**Addendum No. 1
To
Specifications
For Project No. ENG2002871394**

**Description: Public Access Site; Boat Ramp and Parking Lot
Location: Brooksburg, Indiana**

FOR AGENCY: Department of Natural Resources

INDIANA DEPARTMENT OF NATURAL RESOURCES	
BOAT RAMP DETAILS

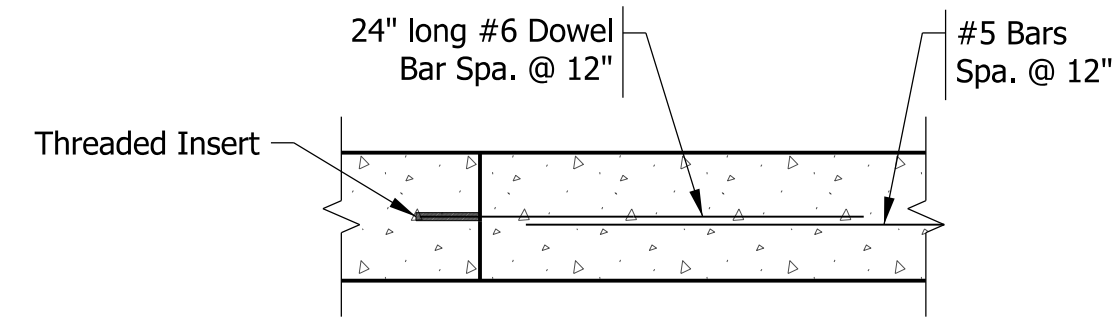
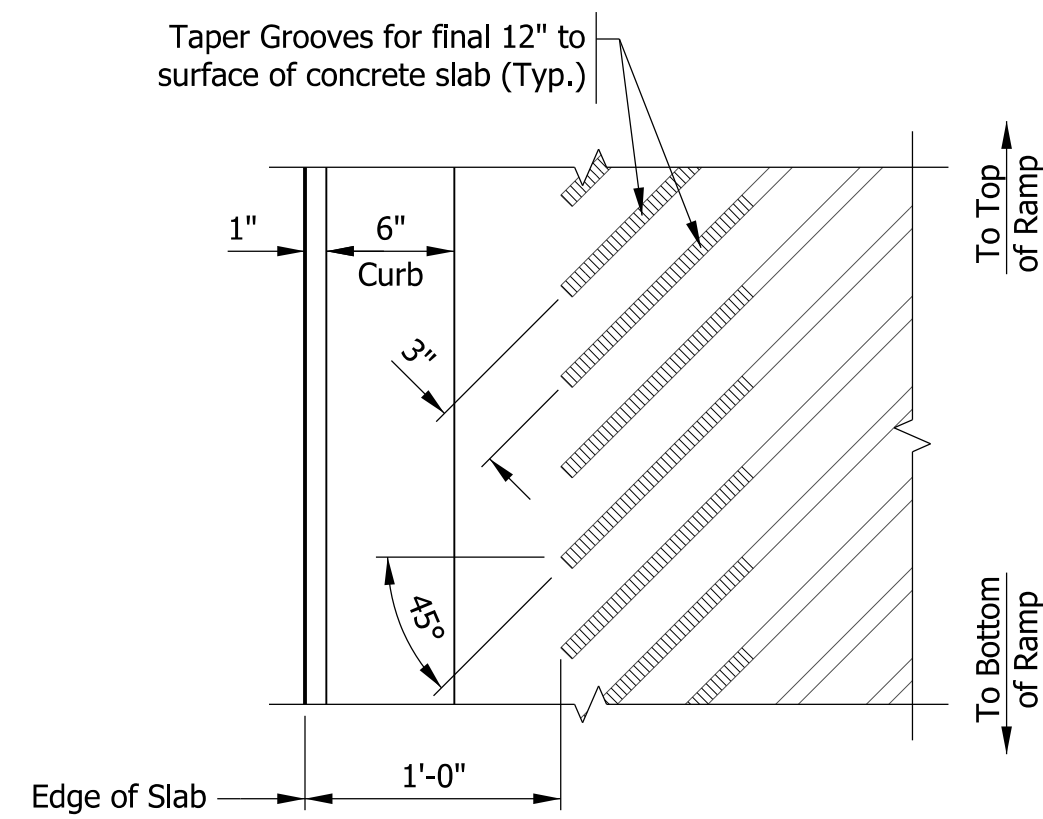
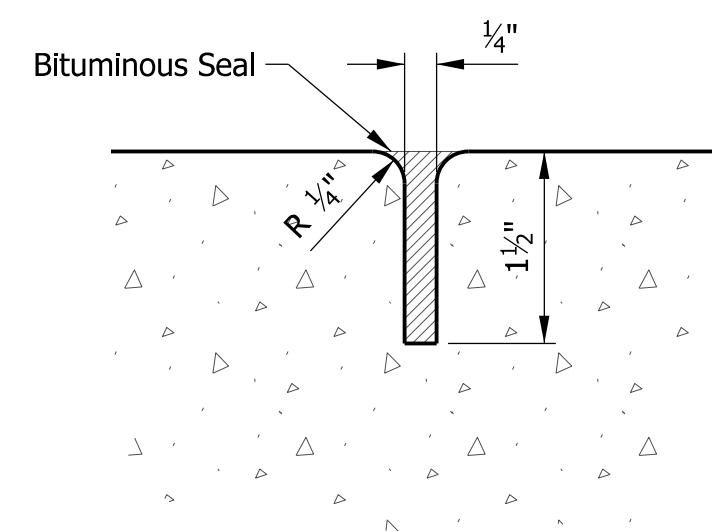
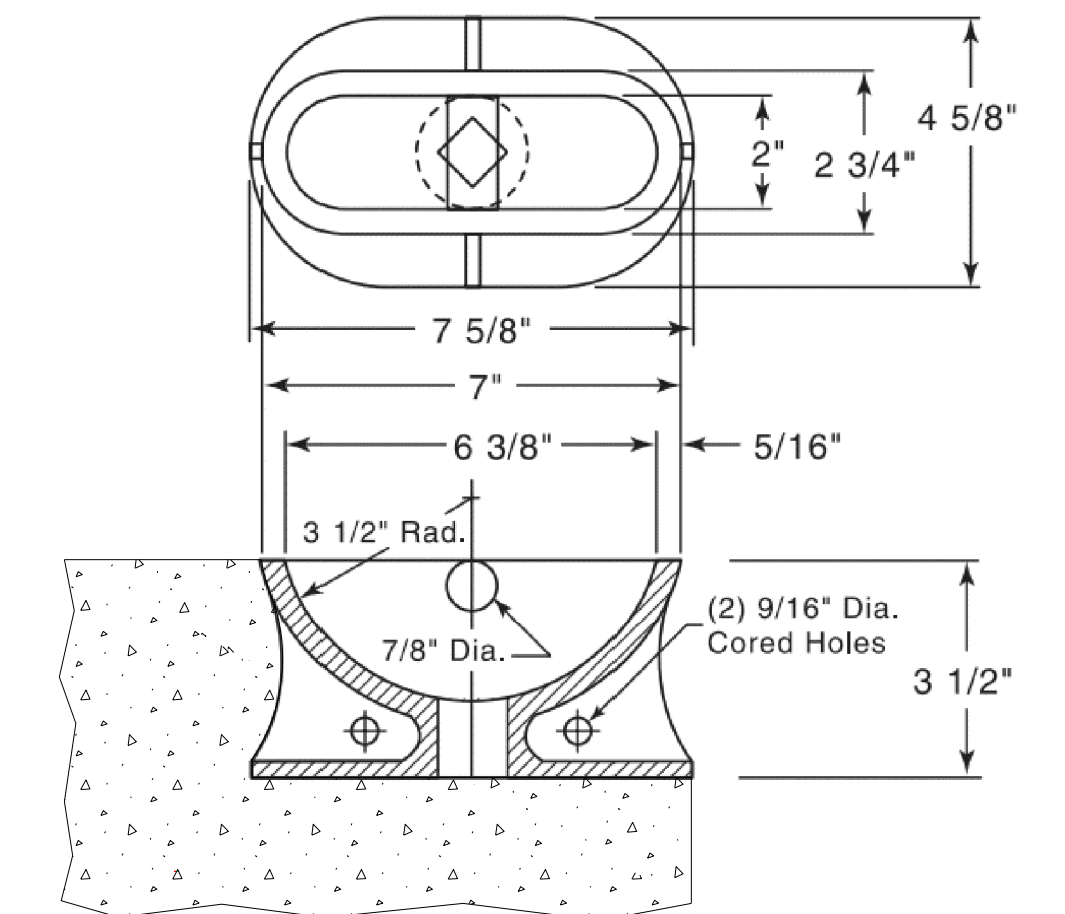
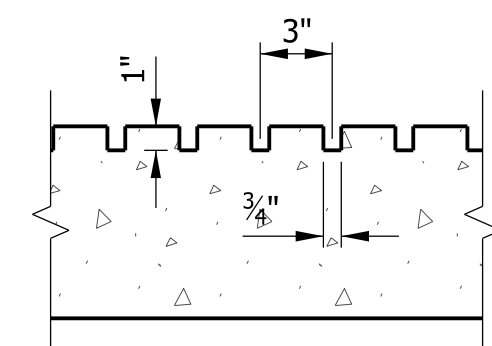
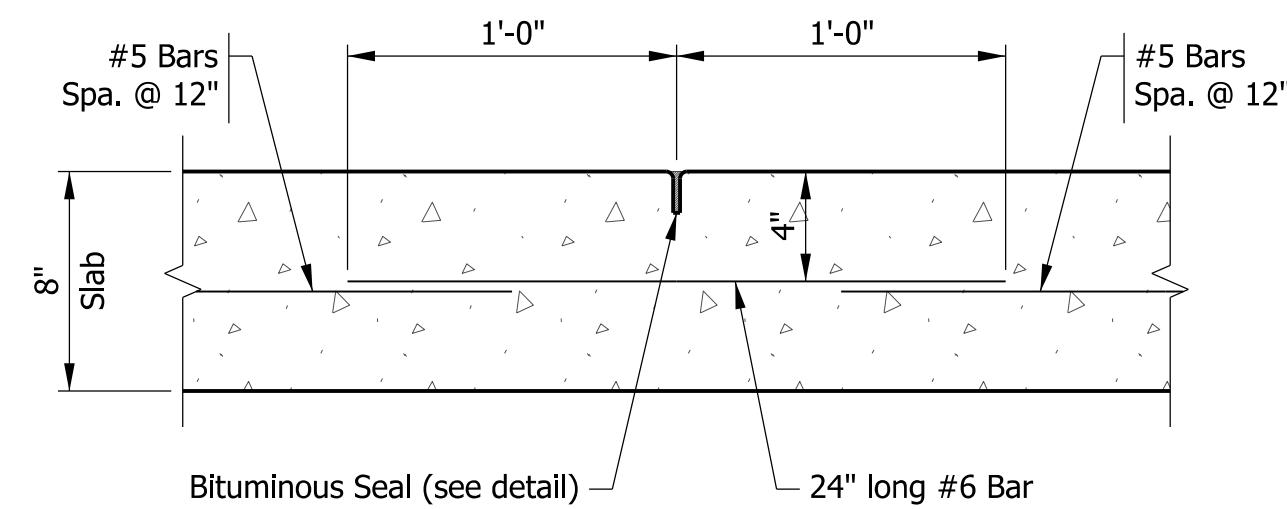
Sheet 4: Skid Ramp Length adjusted to 40'

Q: What are the Mooring Eyes locations/quantity?

Q: Do both Cast-in-place and precast areas of the ramp require grooves?

Q: What is the length of the concrete skid ramp?

A: Two at 15' on Center 3 feet above the OHWM (434.3') and two at 15' on center 3 feet above low pool (418.7')

A: Yes.

A: Contractor can adjust skid ramp length based on water elevations at time of construction/placement. Plans indicate 40 FT

PLAN SHEET
 STA. 0+00.00 TO STA. 4+00.00 "R"

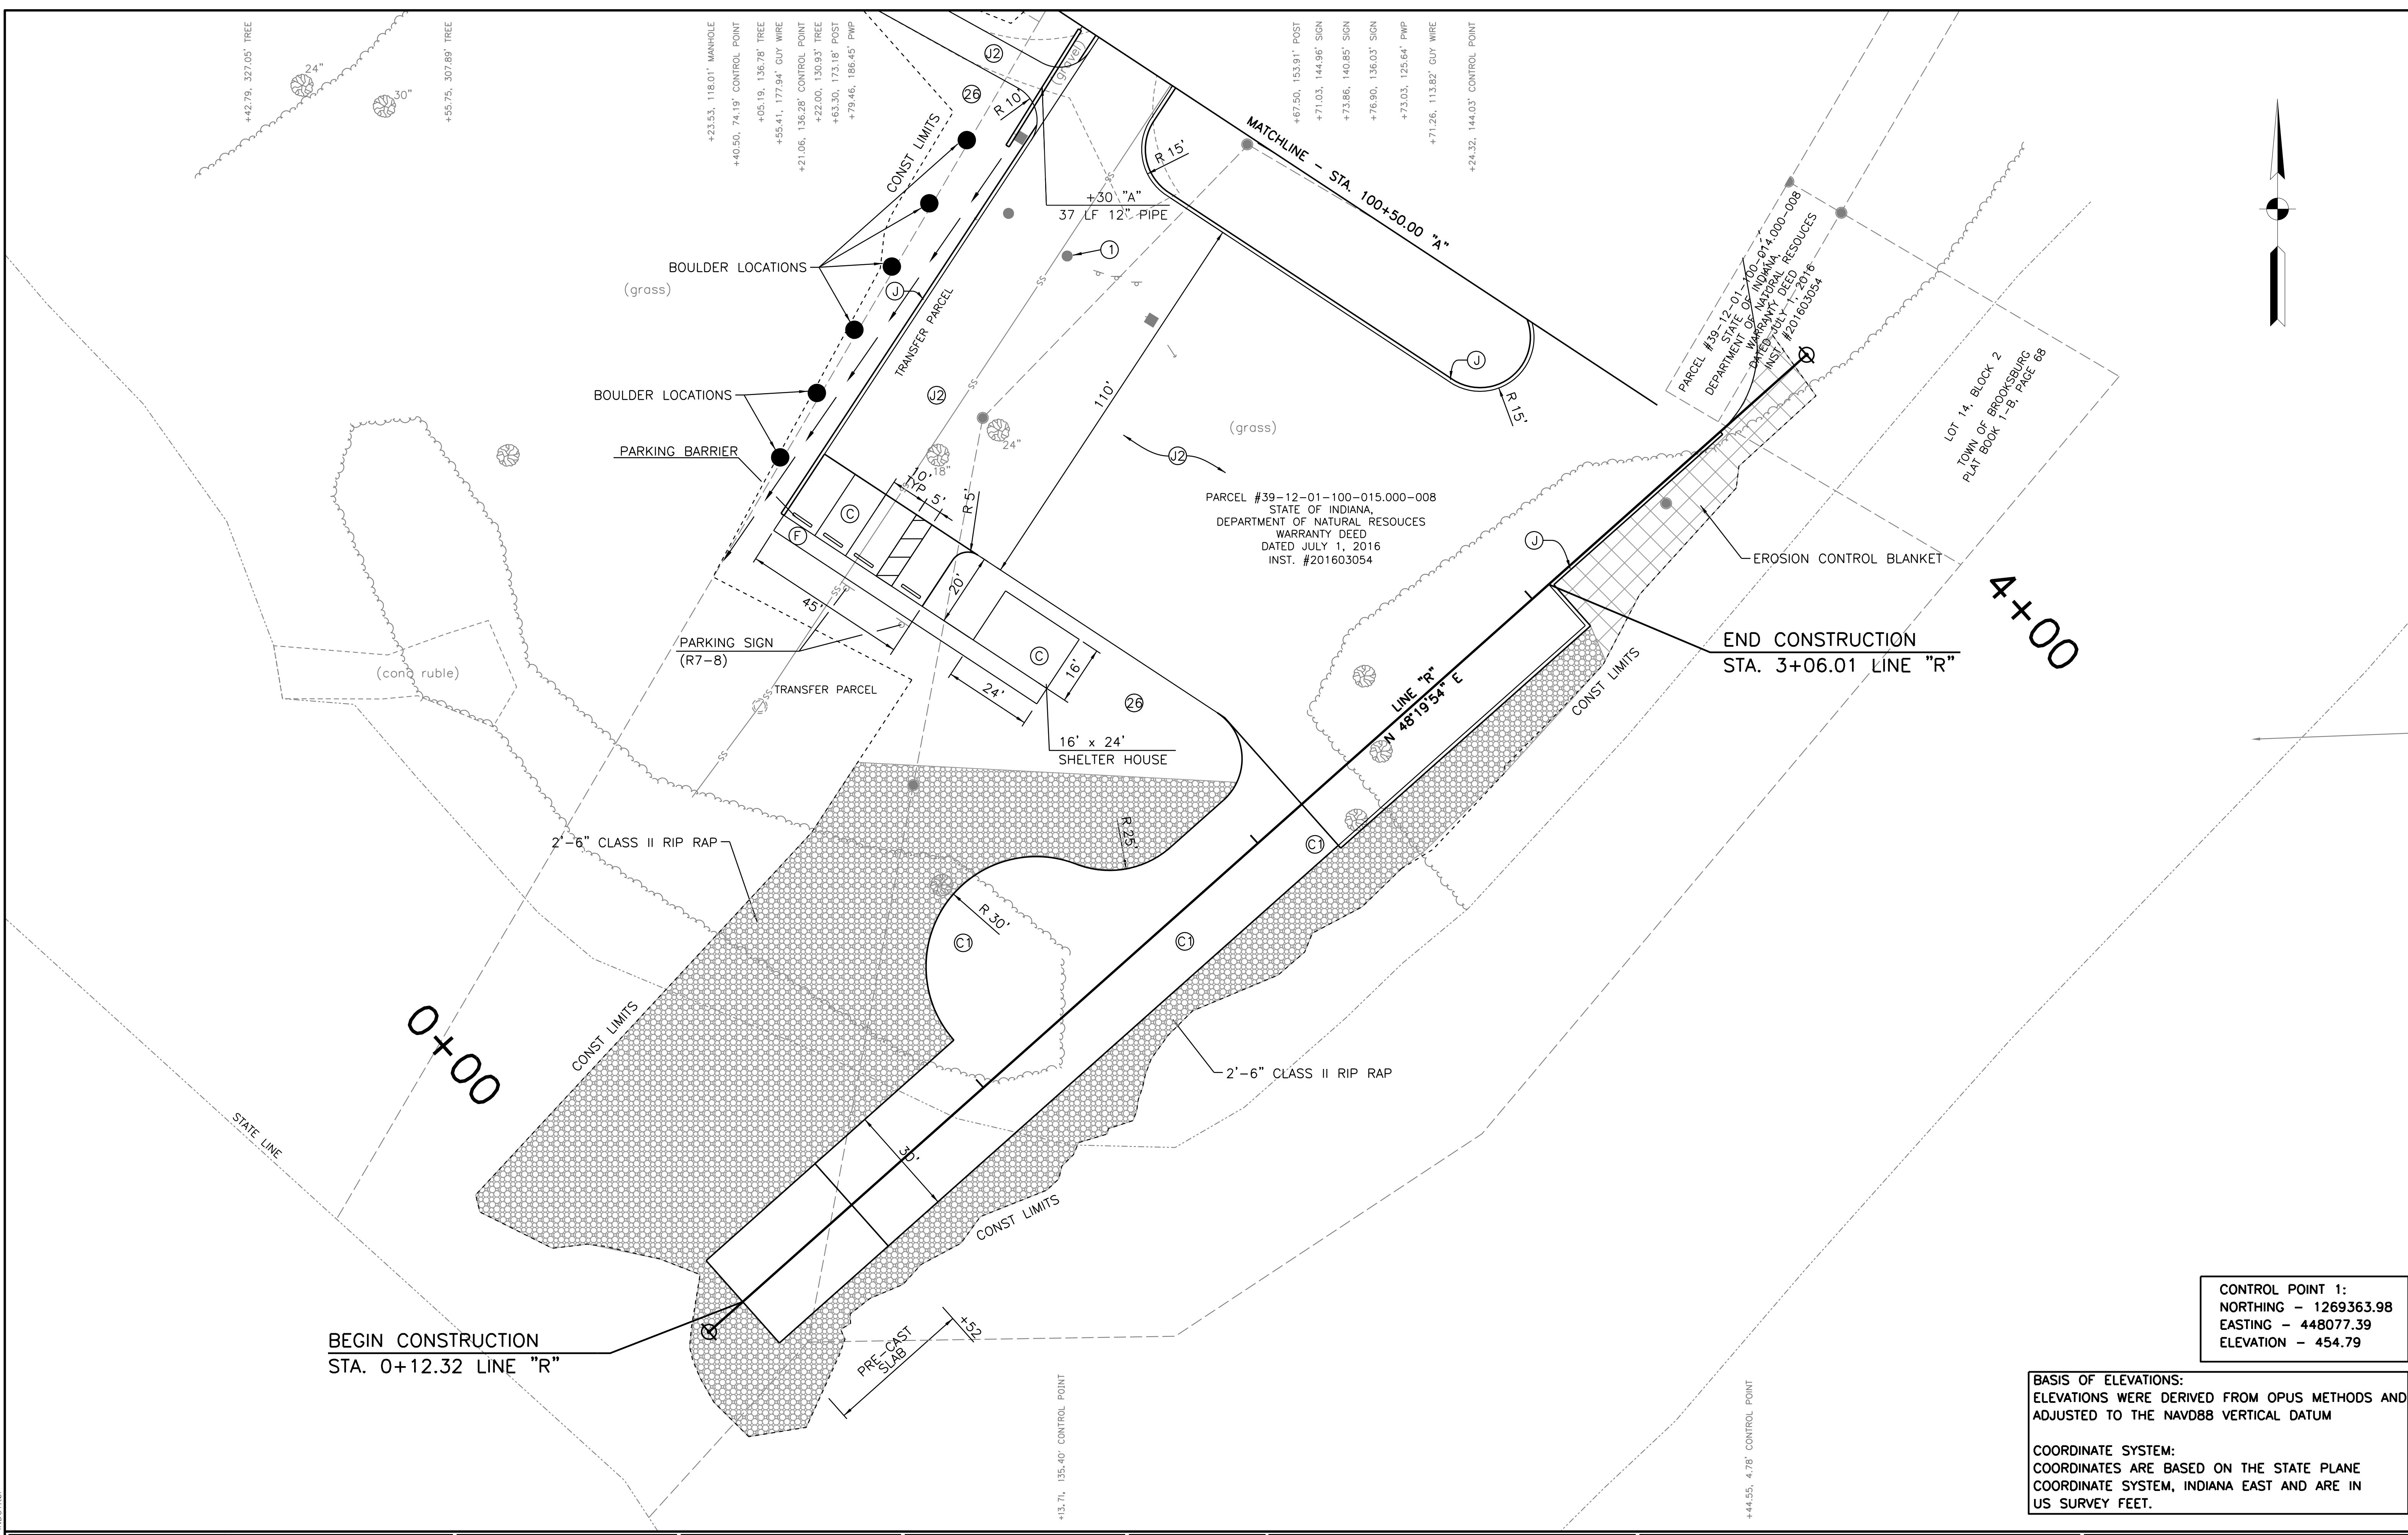
Sheet 8: Concrete depth of ADA parking spaces and shelter house pad changed to 6" Concrete. Updated Aisle width to 5' for ADA area.
